SERVICE DIRECTIVE BULLETIN NO. 0062

Revision 1

1. SUBJECT: Belt Tensioning and Idler System Modifications
2. MODEL: F-28A, 280, F-28C, F-28C-2, F-28C-2R, and 280C
3. EFFECTIVITY: All serial numbers manufactured prior to January 1981
4. BACKGROUND:

Figure 1. Dimension Check for Actuator Arm Clearance

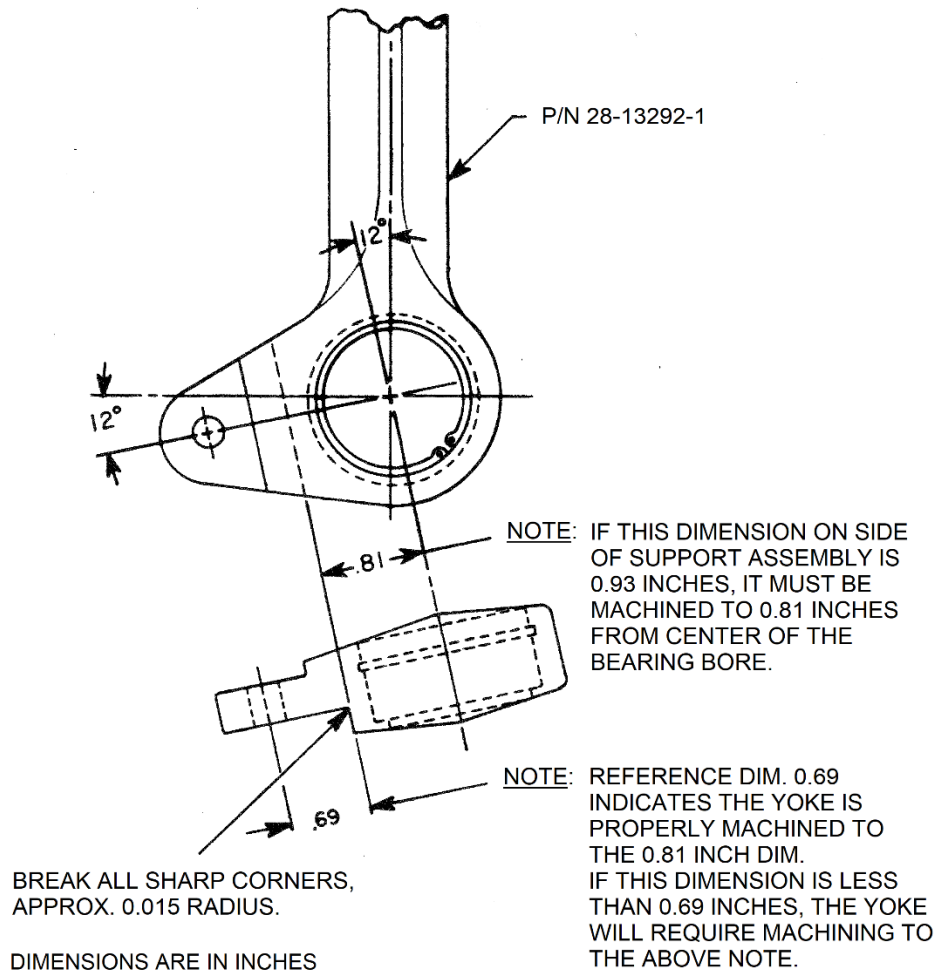
NOTE: Some early model F-28A helicopters may have an idler support assembly, P/N 28-13292-1 installed that may require an additional modification to accept the new actuator arms. See Figure 1 for dimensional check prior to assembly. If dimension is found to be 0.93 inch it should be machined locally to 0.81 inch for proper actuator arm clearance. (Reference Maintenance Manual Section 8, for idler assembly removal procedure.)
